Subject: FW: 05533254 Jacktrees Road ,Cleator Moor, Moor Row, Cleator Moor, Cumberland, CA25 5NT

Subject: RE: 05533254 Jacktrees Road ,Cleator Moor, Moor Row, Cleator Moor, Cumberland, CA25 5NT

Photo No. 0928

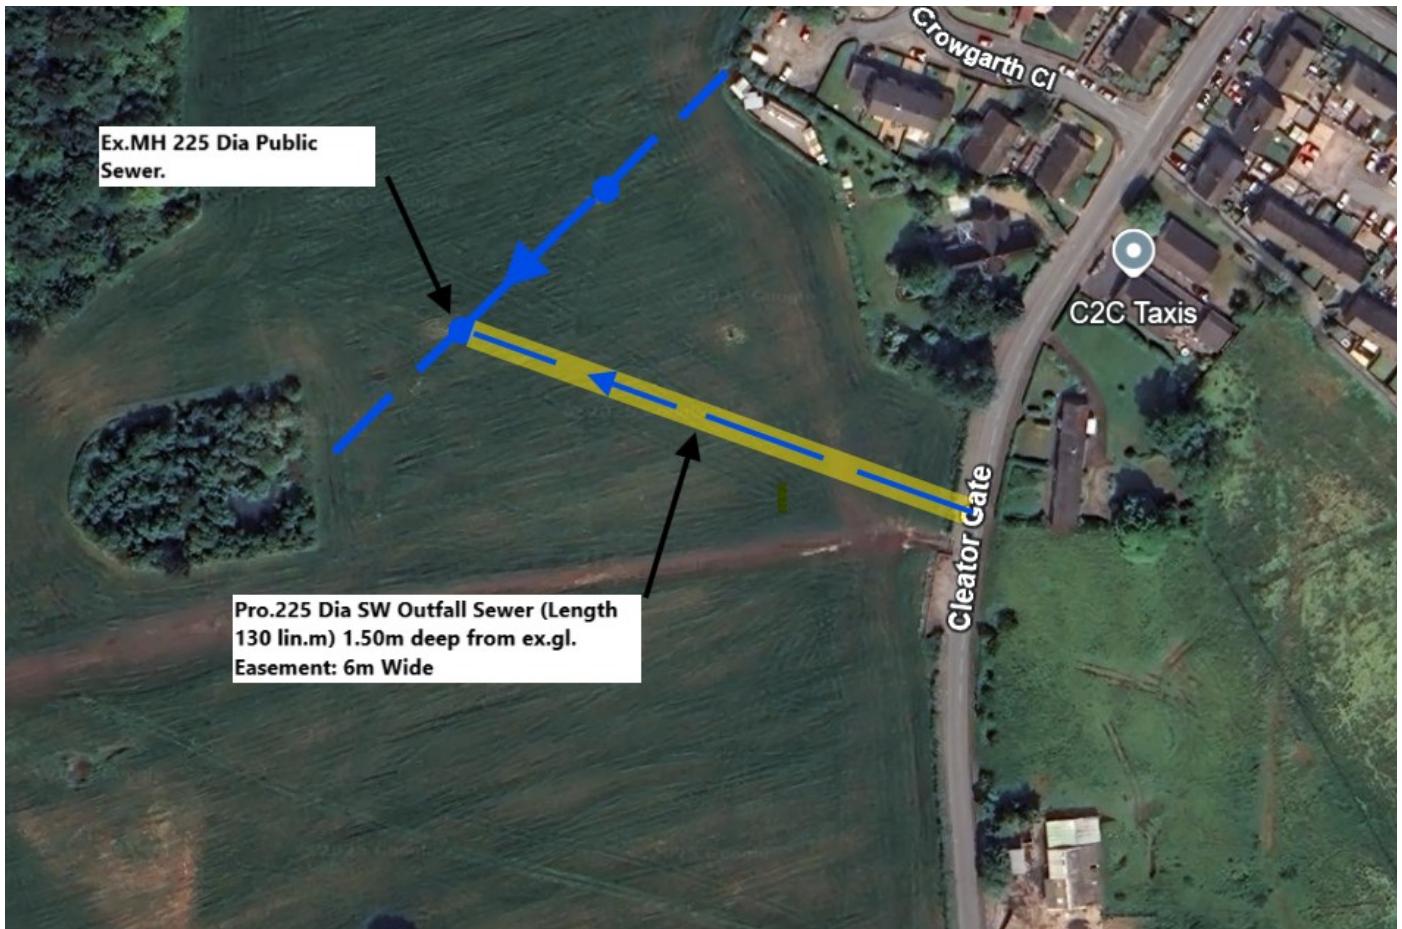
Photos 0928 & 0910 (see screenshot below) show the watercourse and the cover stone over the same to the location of the footpath. The watercourse can be best described as an overland route rather than a clearly defined ditchcourse suitable for discharging albeit restricted surface water flows from the housing development. Also, the watercourse is located on the farmland adjoining Donaldson Dairy's land, which we have had favourable discussions concerning an easement over their land (see screenshot below).

I would, therefore, propose the restricted surface water flows from the housing development (Phase 1 & 2) discharge by gravity sewer to the existing 225 Dia., gradient of 1/19 public sewer, which outfalls to the pond located within Donaldson Diary's farmland. Please see attached Lidar survey (PDF) showing the topography of the Dairy's farmland, receiving Pond and ex. public sewer. Notably, there are 2No manholes on the line of the public sewer located within the farmland that aren't shown on the sewer records.

As discussed, I am happy to confirm we will accept surface water flows to the 225mm public surface water sewer to the west of the site, subject to confirmation the discharge has onward flow to a recognised watercourse. Discharge rates must be restricted to the greenfield QBAR runoff rate which is 20.5 l/s (based on 2.1ha stated on the originally submitted enquiry form, using the IH124 method).

As discussed, a surface water pumping station is not required for this connection.

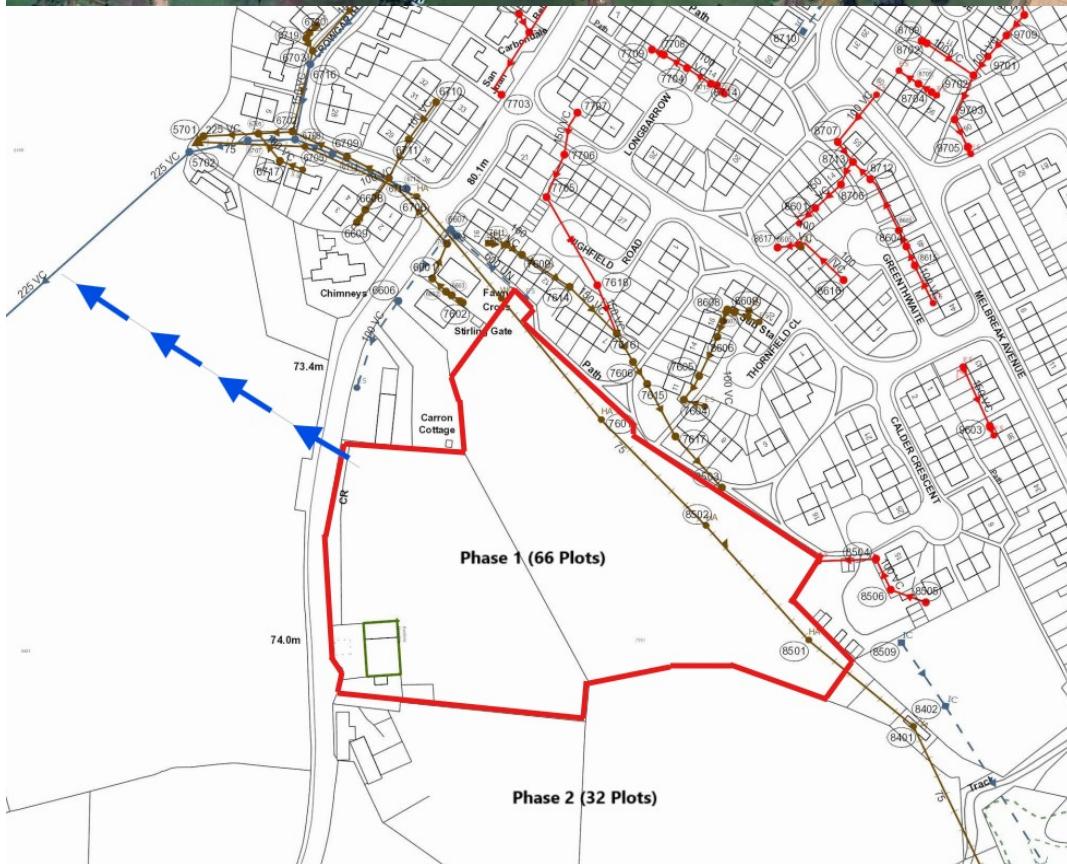
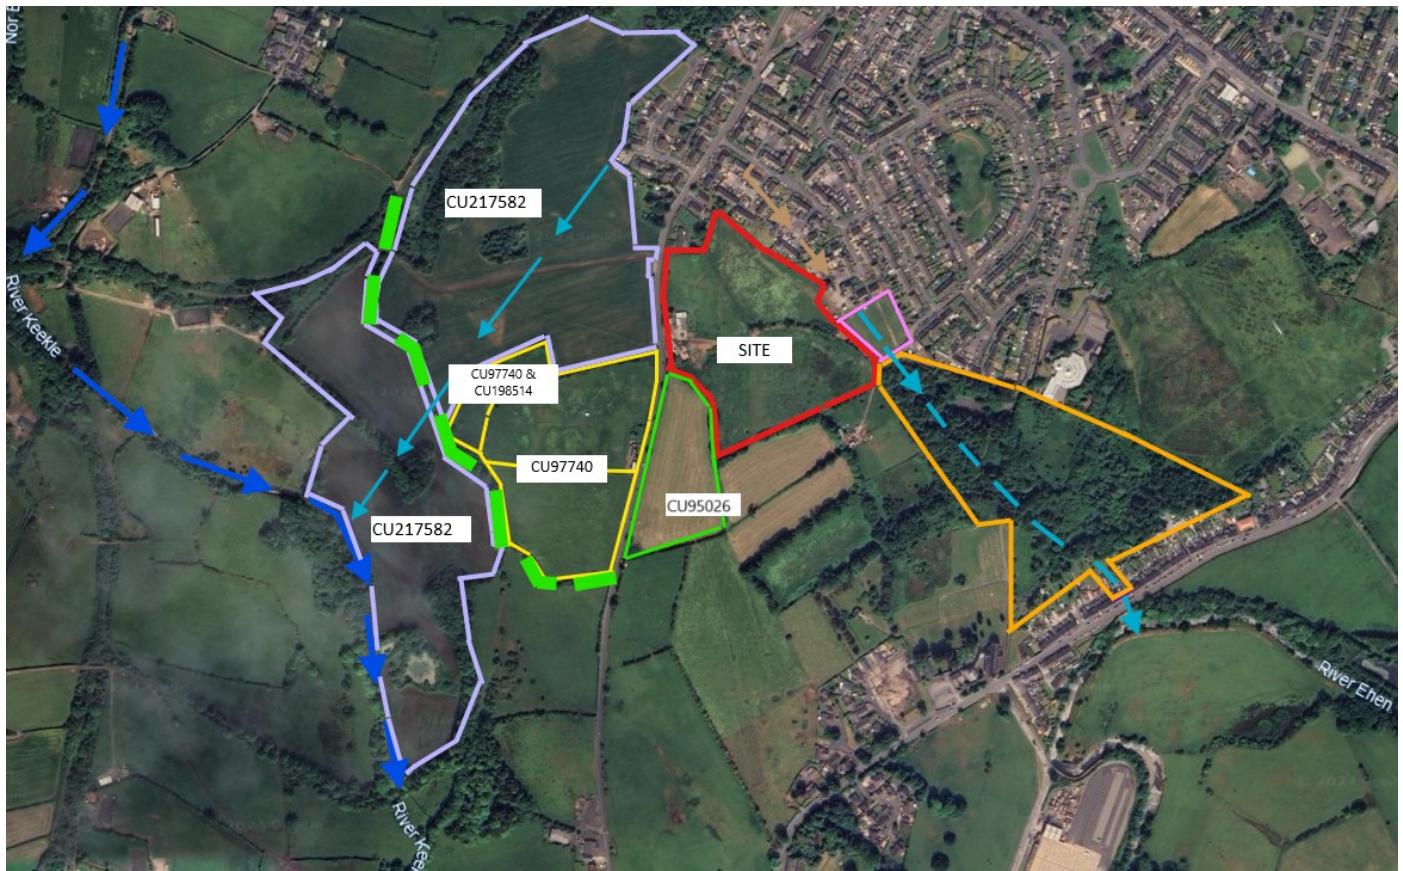
I have entered into discussions with the riparian owner of the parcels of land shown edged Purple (CU217582) and Yellow (CU97740) concerning obtaining their approval to construct the proposed surface water outfall sewer serving our development over their land to the R. Keekle.

I am having difficulty contacting the riparian owner of the land edged Green (CU95026) who no longer lives at the address registered on the 'Official copy of the register of title' for the land. We can't rule out the owner has passed away and there may be complication with the registered title of the land that could take a considerable time to resolve (see screenshot below & attached).

In view of the issues and difficulties we have faced to date with negotiating and obtaining the approval needed from the riparian owners to construct an outfall structure over their land I would like to put forward an alternative proposal for the surface water outfall to be lifted by way of a submersible pumping station to a POC located on the existing 275 Dia public sewer that is located within the land edged Purple (CU217582) and outfalls to the R. Keekle. (see screenshot below & attached).

I have had more favourable discussions with the riparian owner of the land edged Purple (CU217582) and believe I will obtain their approval to construct the surface water outfall to the POC located on the aforementioned existing 275 Dia. public sewer

Thank you for detailing the issues with obtaining landowner permissions. To reach a watercourse. I accept a solution which only includes crossing the land marked in purple in your email is required, i.e. I accept the land boundaries marked in green and yellow are unlikely to be possible to cross.

There does appear to be a watercourse on the boundary between the purple and yellow areas, so a watercourse system of some kind may well be reachable without crossing the yellow or green boundaries. I have circled this red in the attached snippet. This is likely where the flows from our surface water sewer (which is mapped to outfall to natural ponds just north) will end up. So another option may be to discharge directly to the same natural ponds that our existing sewer discharges to. These options would need to be explored further, but ultimately if these are explored and properly discounted then I would be willing to accept a connection to public 225mm surface water sewer.

I would also comment that the topo lines suggest it is roughly downhill to this area from the site, so I would not envisage a pumping station being required. We would require detailed justification/evidence proving a pumping station is required before we would consider adopting one (whether the outfall ends up being to watercourse or to the public surface water sewer).
